BROWNS FERRY NUCLEAR PLANT (BFN) – UNITS 1, 2, AND 3 – TECHNICAL SPECIFICATIONS (TS) CHANGES TS-418 AND TS-431 – EXTENDED POWER UPRATE (EPU) – RESPONSE TO ROUND 23 REQUEST FOR ADDITIONAL INFORMATION (RAI) REGARDING STEAM DRYER SIGNAL PROCESSING (TAC NOS. MD5262, MD5263, AND MD5264)

**TENNESSEE VALLEY AUTHORITY
BROWNS FERRY NUCLEAR PLANT (BFN)
UNITS 1, 2, AND 3**

**TECHNICAL SPECIFICATIONS (TS) CHANGES TS-431 AND TS-418
EXTENDED POWER UPRATE (EPU)**

**RESPONSE TO ROUND 23 REQUEST FOR ADDITIONAL INFORMATION (RAI)
REGARDING STEAM DRYER SIGNAL PROCESSING**

Figure EMCB.203-1.3a: Phase of measured data for BFN1 main steam line A, for CLTP conditions (black, top) and corresponding EIC (red, bottom).

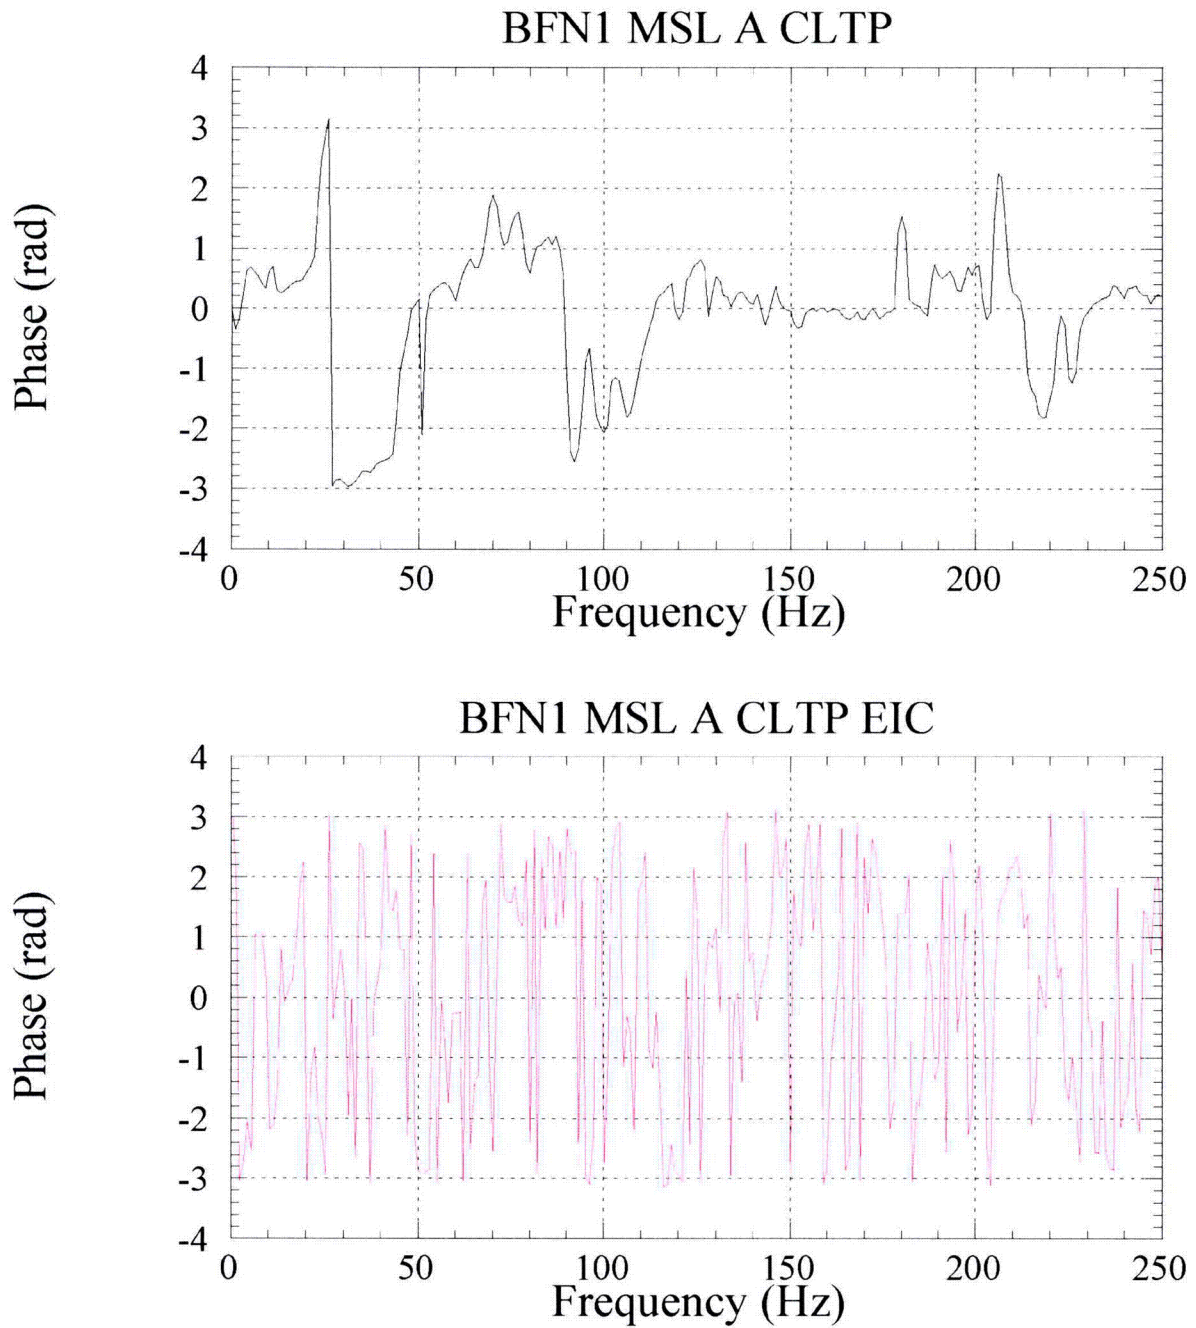
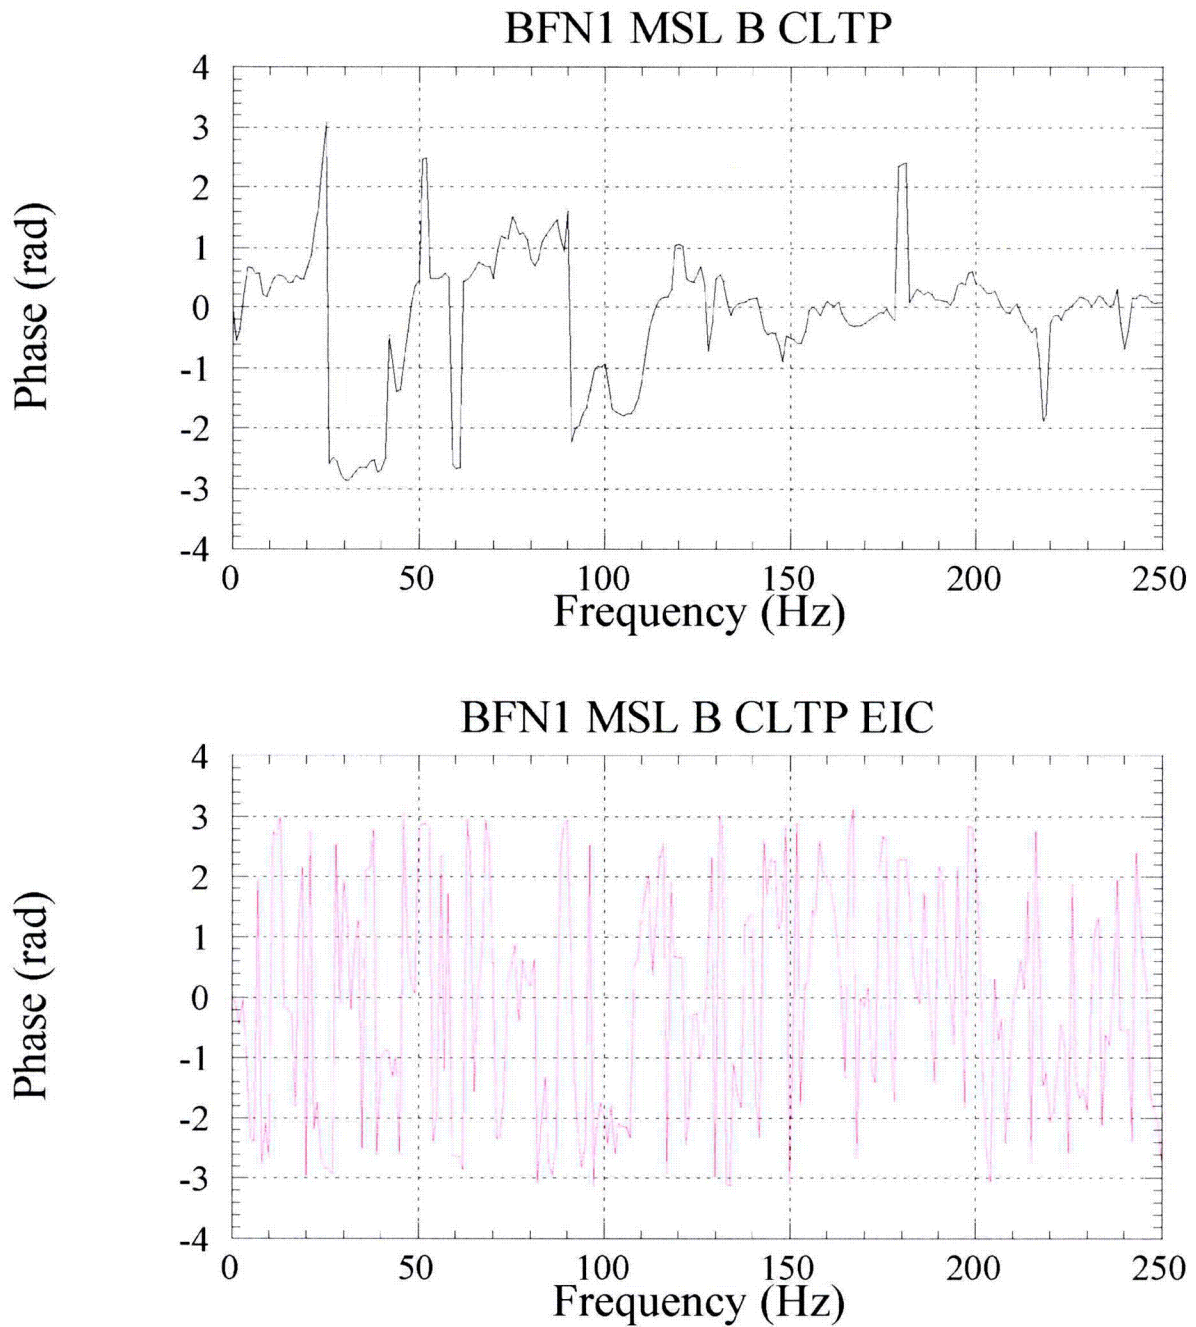
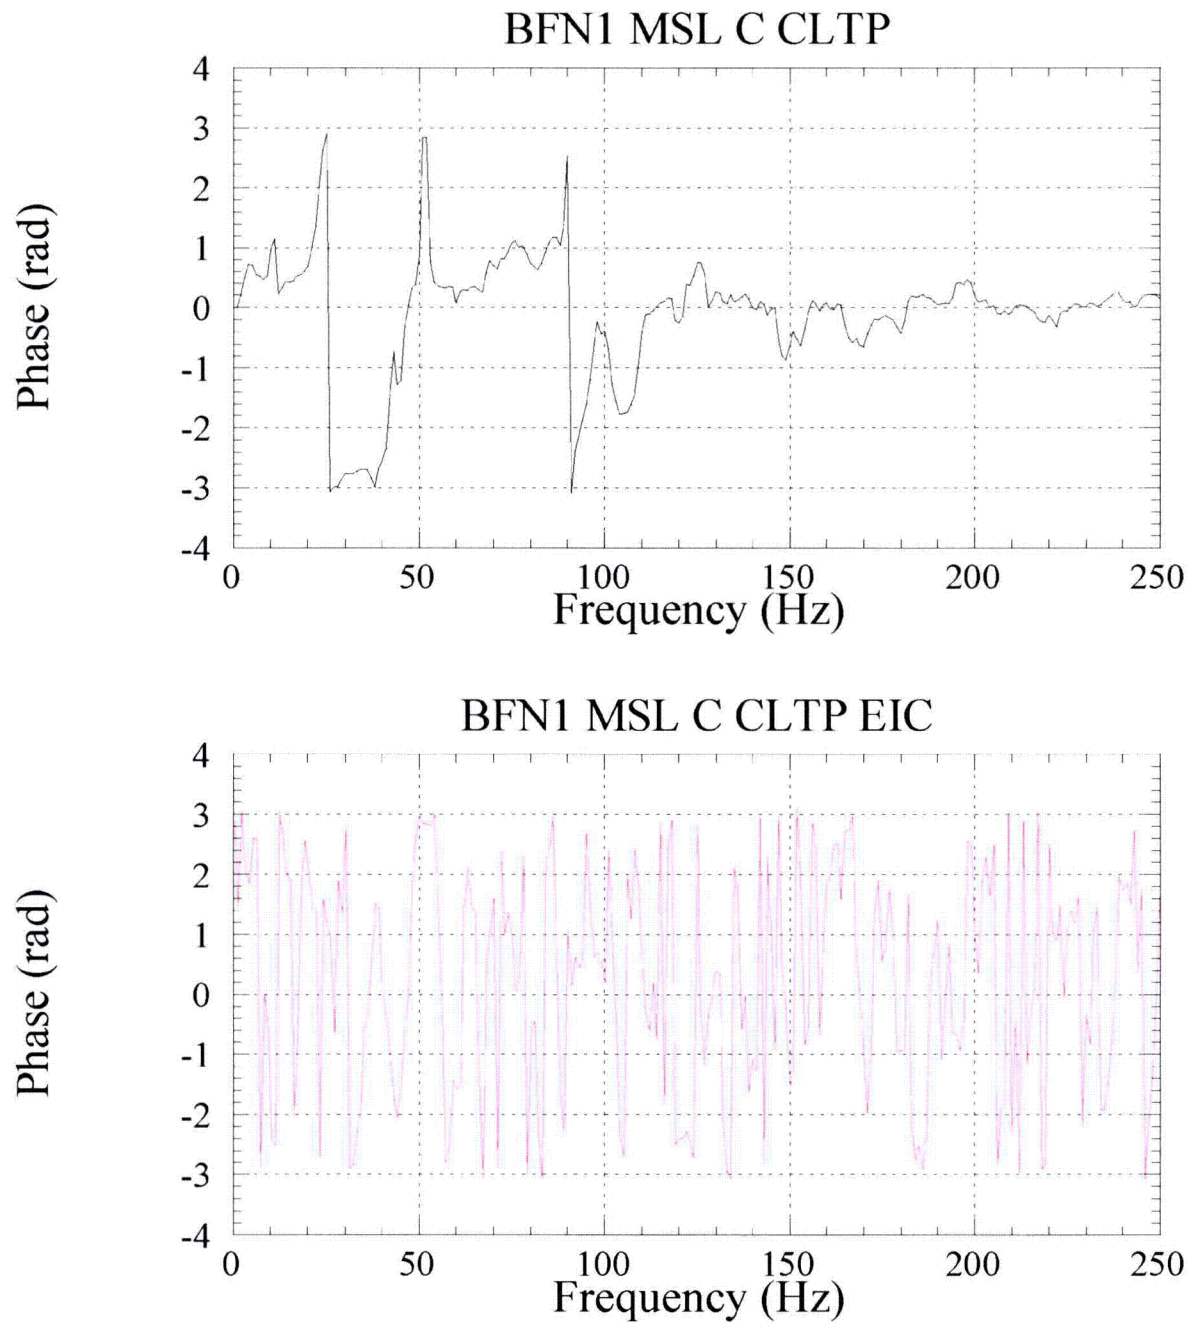
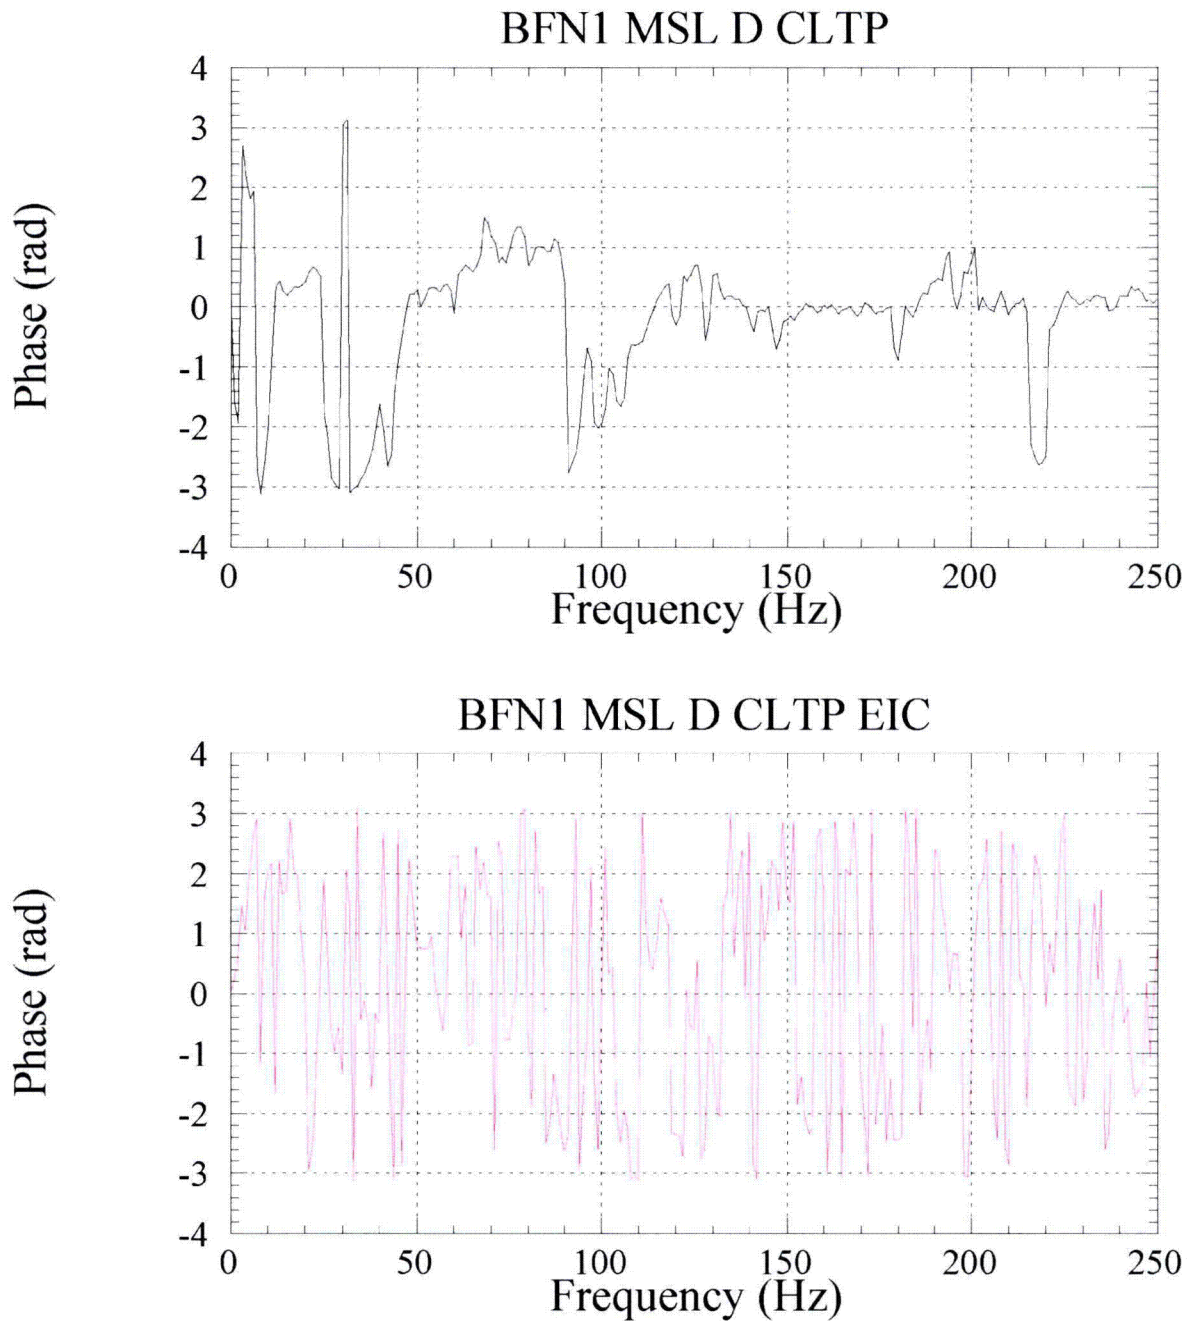
In response to EMCB.200/157., TVA presents detailed discussion of signal conditioning in six steps. Provide plots of strain gage signals (autospectra, cross spectra, coherence, and phase) and computed [[]] throughout the procedure described in their RAI response (prior to step 1, after step 1, after step 2, after step 4 and after step 6), for current license thermal power (CLTP) and Low Flow (LF) signals, for Units 1 and 2.

The requested plots for Unit 1 are listed and provided below. The requested plots for Unit 2 are scheduled to be provided by January 23, 2009.
